North Valley Farms 2nd Addition

RE: SUB 2001-80 -- Final Plat of North Valley Farms Second Addition

October 19, 2001

CASE NUMBER: SUB 2001-80 -- NORTH VALLEY FARMS SECOND ADDITION

North Valley Farms 2nd Addition

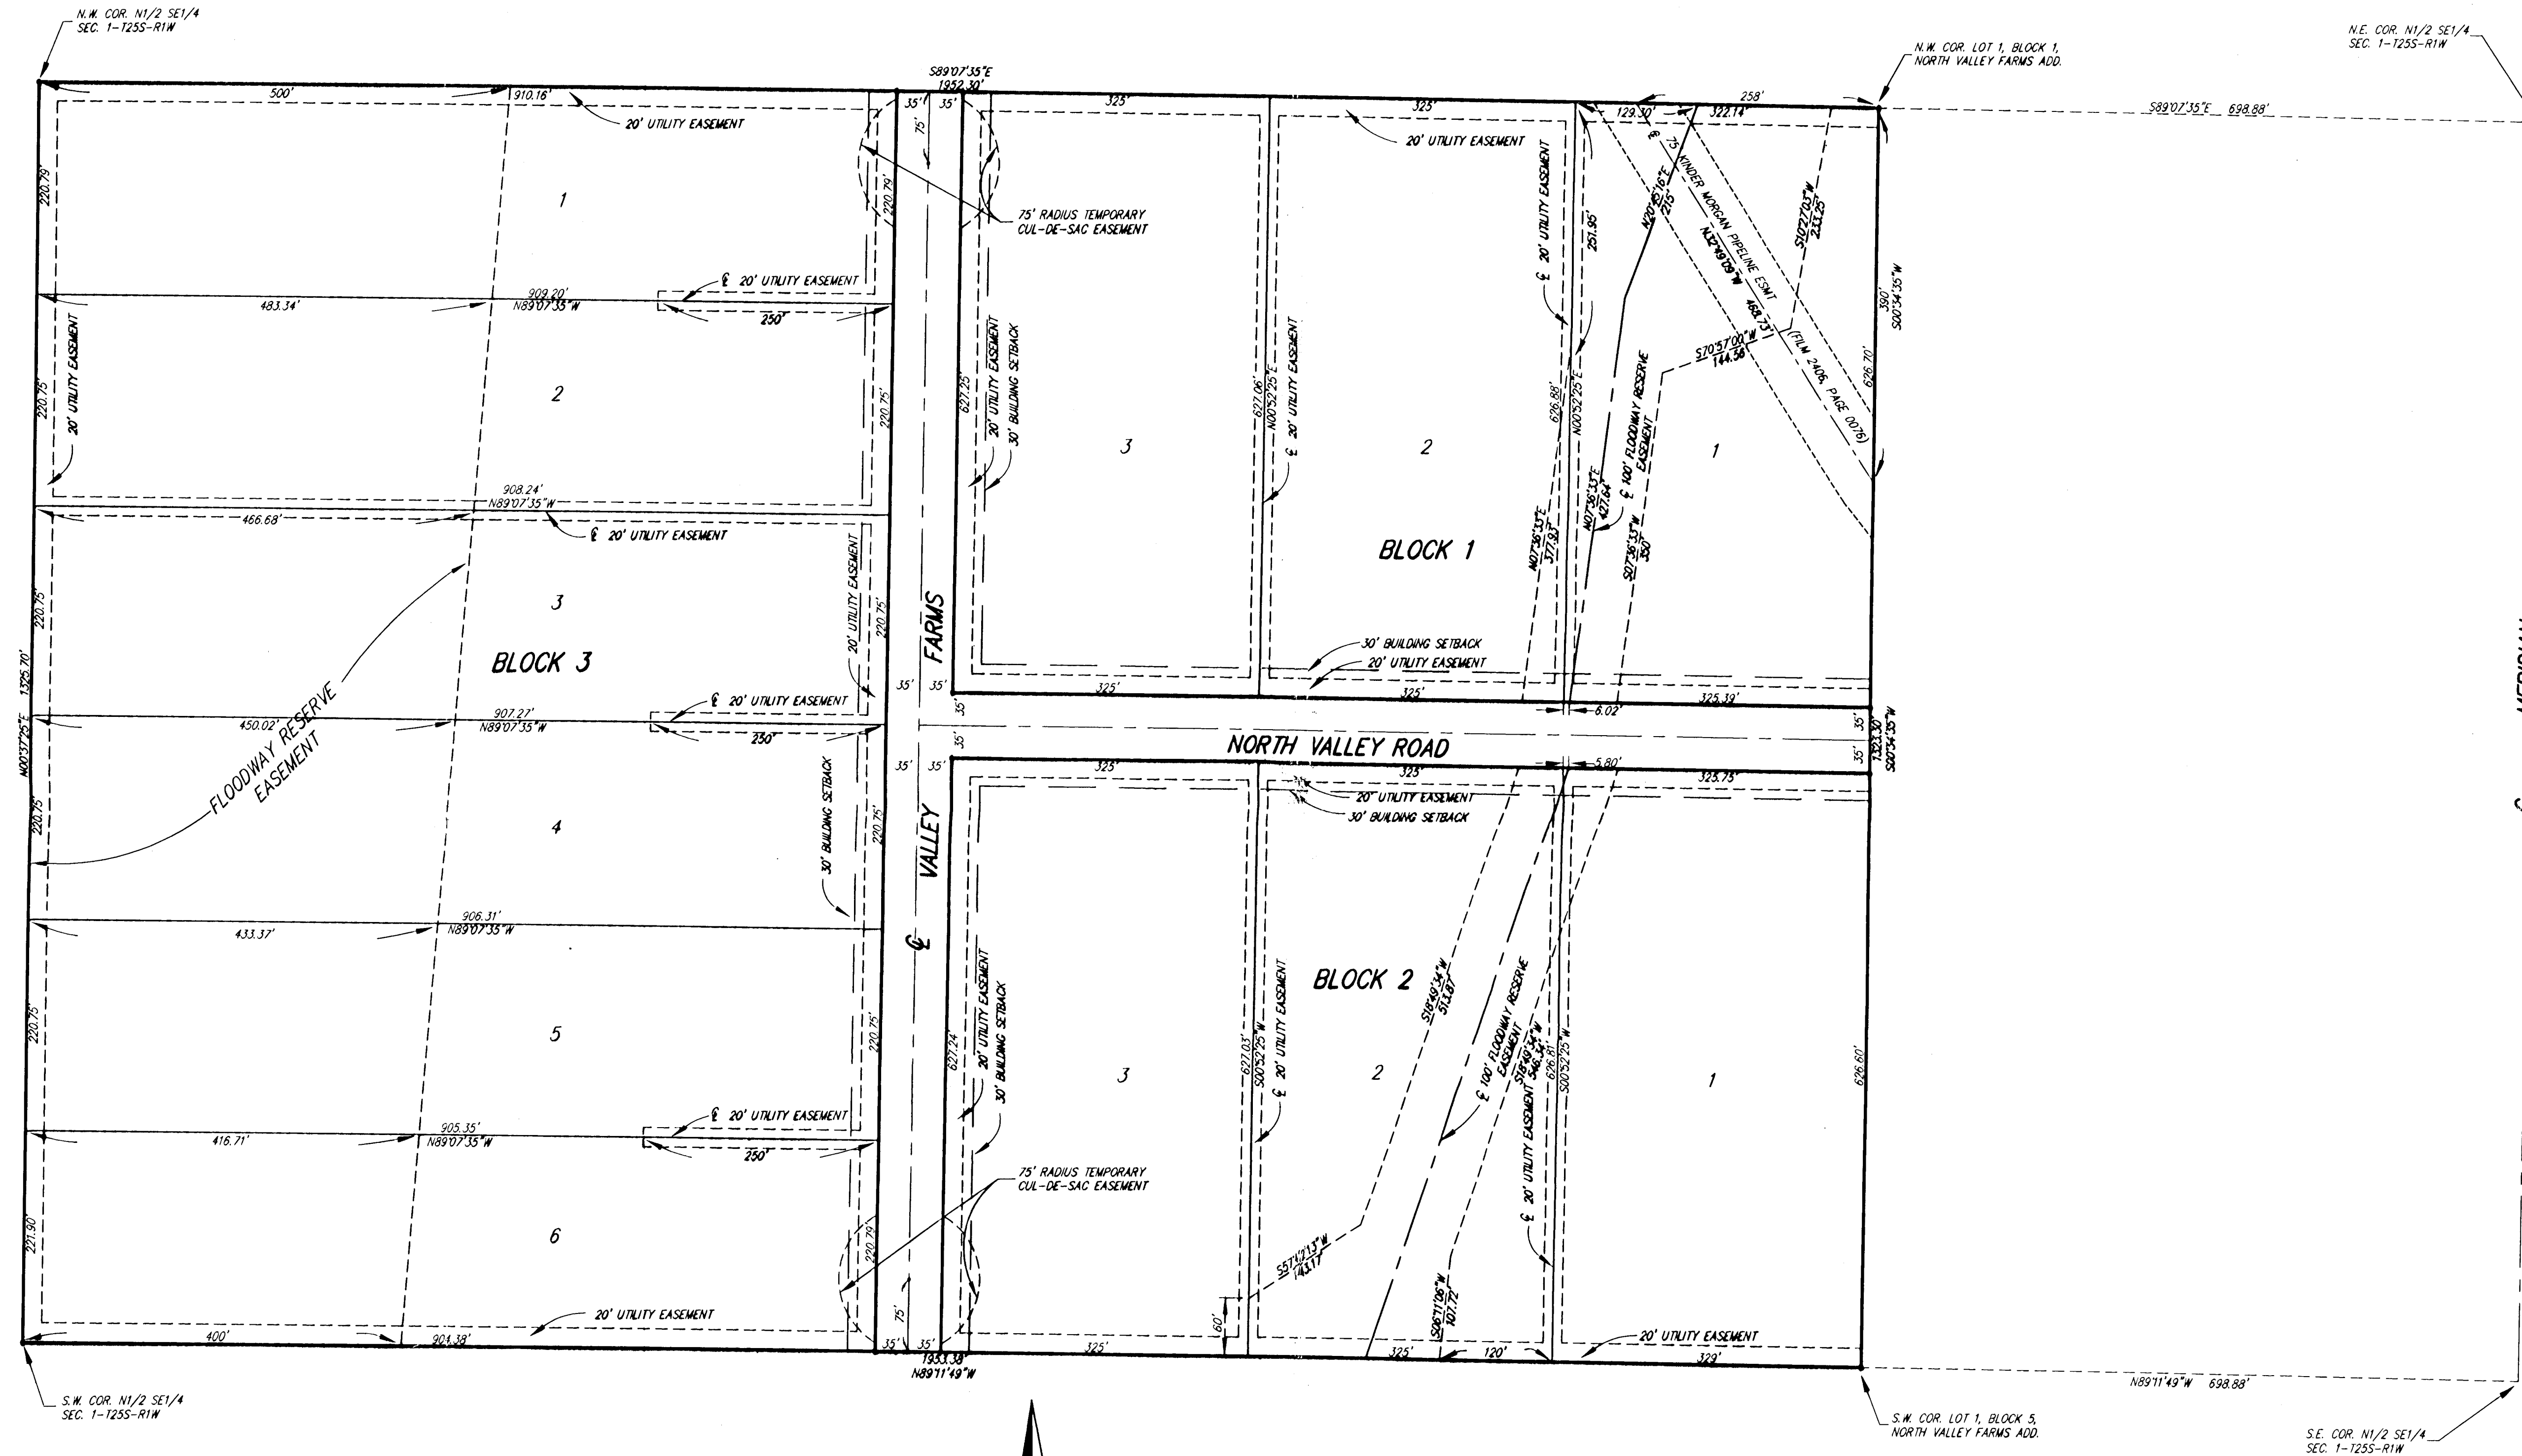
- A. Since neither municipal water nor sanitary sewer is available to serve this property, the applicant shall contact the Environmental Health Division of the **Health Department** to find out what tests may be necessary and what standards are to be met for approval of on-site sewerage facilities and water wells. A memorandum shall be obtained specifying approval. **Health Department** should comment on the floodway reserve constraints impacting on the buildable area. **A restrictive covenant will be needed to address required twin lagoons for Block 3.**

- C. **County Engineering** needs to comment on the status of the applicant's drainage plan. **A HEC 2 Run and Master Lot Grading Plan are required.**
- D. The applicant shall guarantee the installation of the proposed streets to the 36-ft rock standard. The guarantee shall include the elimination of the existing cul-de-sac at the terminus of North Valley Road.

- F. The length of the internal street is approximately 2,250 feet (measured from Meridian), exceeding the 1,200-ft limitation of the Subdivision Regulations. Approval of the plat will require a modification. **A modification has been approved by the Subdivision Committee.**

- H. Approval of this plat will require a waiver of the lot depth to width ratio of the Subdivision Regulations for Lots 1 through 6, Block 3. The Subdivision Regulations state that the maximum depth of all residential lots shall not exceed 2.5 times the width. *A modification has been approved.*

- K. The MAPC signature block needs to reference "J.D. Michaelis, Chair".
- L. The applicant shall submit a copy of the instrument which establishes the pipeline easements on the property, which verifies that the easements shown are sufficient and that utilities may be located adjacent to and within the easements.

- M. The applicant's agent shall determine any setback requirements for the pipelines by researching the text of the pipeline agreements. If a setback from the pipeline easements is provided for in the pipeline easement agreements, it shall be indicated on the face of the plat.

- N. The recording information for all pipeline easements shall be indicated on the face of the plat.
- O. The Applicant is reminded that a platting binder is required with the final plat. Approval of this plat will be subject to submittal of this binder and any relevant conditions found by such a review.

- P. The plat's text shall include language that a drainage plan has been developed for the plat and that all drainage easements, rights-of-way, or reserves shall remain at established grades or as modified with the approval of the applicable City or County Engineer, and unobstructed to allow for the conveyance of stormwater.

- X. The representatives from the utility companies should be prepared to comment on the need for any additional utility easements to be platted on this property. ***KGE has requested additional easements.***
